SB-10051922-5438 *Service Bulletin*

Applies To: 2009-11 TSX L4 with M/T - Check the iN VIN status for eligibility

Product Update: Software Update to Improve Fuel Injector and VTC Timing (Supersedes 11-021, dated October 22, 2011, to revise the information marked by the black bars)

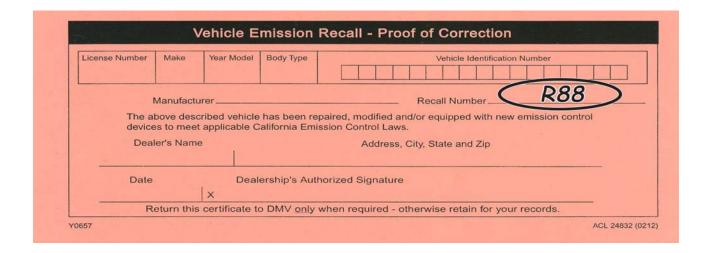
- 1. Update the PGM-FI software. Refer to Service Bulletin 01-026, *Updating Control Units/Modules*.
- 2. Center-punch a completion mark above the third character of the engine compartment VIN:
